STRATEGIC PETROLEUM RESERVE PROJECT PROPOSAL

CONTRACTOR CHANGE NO.: 74007 | REV: 1

TITLE: CONNECTION TO EXXON SHIP SHOAL AND TEXACO PIPELINES

ECP NUMBER	TITLE
SJ-M/O-4606 Revision 1	Connection to EXXON, SHIP SHOAL and TEXACO PIPELINES

SJ-M-103-019

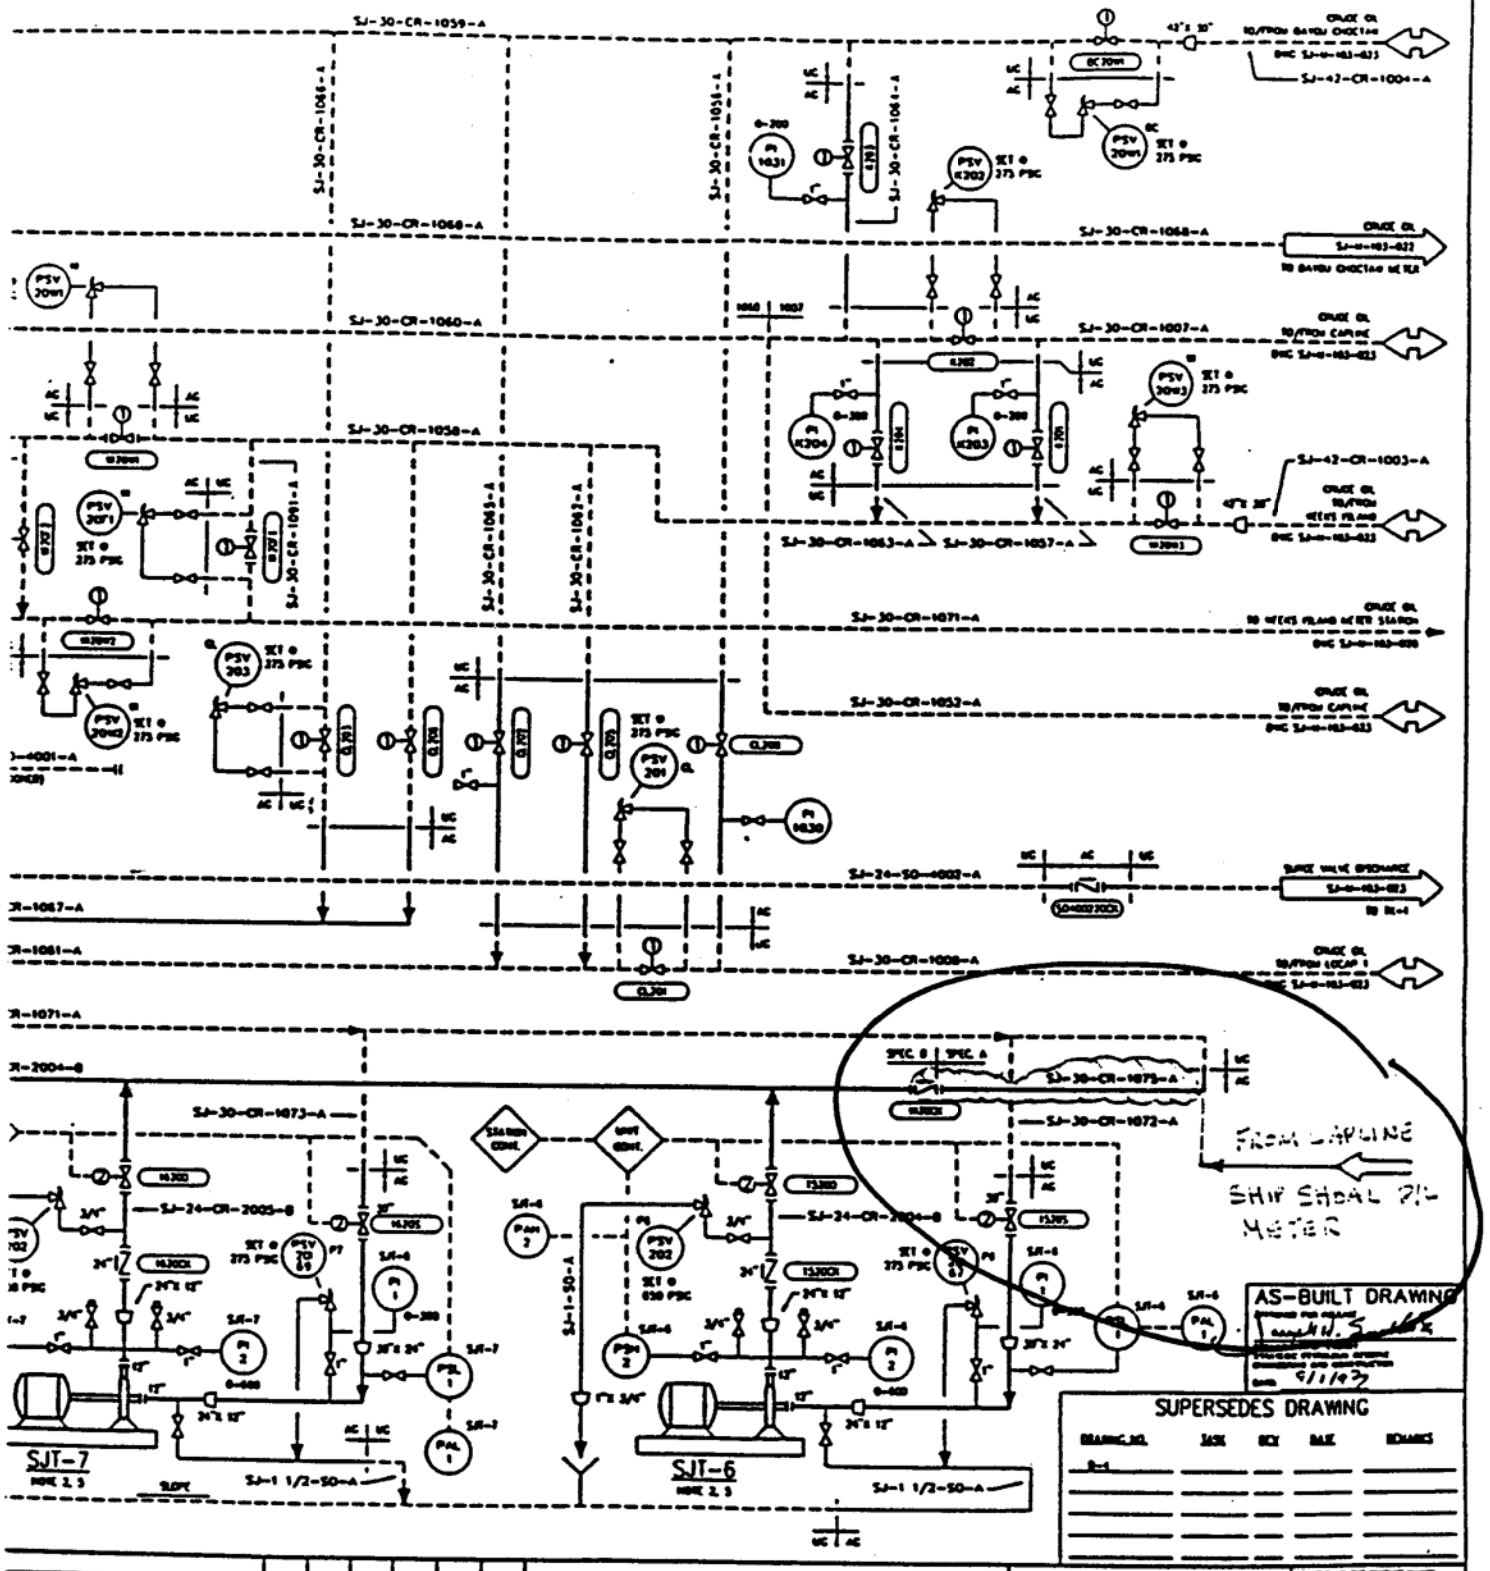
The original plan was to tie the new line in near the suction of pumps SJT-6/7/8. The new plan will make the tie in on the inlet side of the Bayou Choctaw meters. We will also use an abandond 30" line that DOE installed. According to Scott Landry, DM, this was one of two lines intended for a connection to Capline, but was abandoned before being put in service. We will inspect and hydrotest the 30" line before placing it in service. Because the flow rates from the Exxon pipeline are low (approximately 3500 BPH), we will also need to replace one of the 12" turbine meters in the Bayou Choctaw meter skid with an 8" helical turbine flow meter. This will reduce the maximum flow rate through the meter skid from 64,200 BPH to 49,000 BPH. I believe this is still higher than the maximum drawdown rate from Bayou Choctaw. We plan to keep the 12" turbine meter in the warehouse and can replace it in the meter skid with 1 to 2 days notice if needed.

A new pipeline will be laid between the Capline and Sugarland Terminals. The line will connect to the Exxon, Ship Shoal, and Texaco pipelines on Capline property. The tie-in to Sugarland will be made into line SJ-30-CR-1015-A near the suction of pumps SJT-6/7/8. See the attached P&ID and Valve Chart for details.
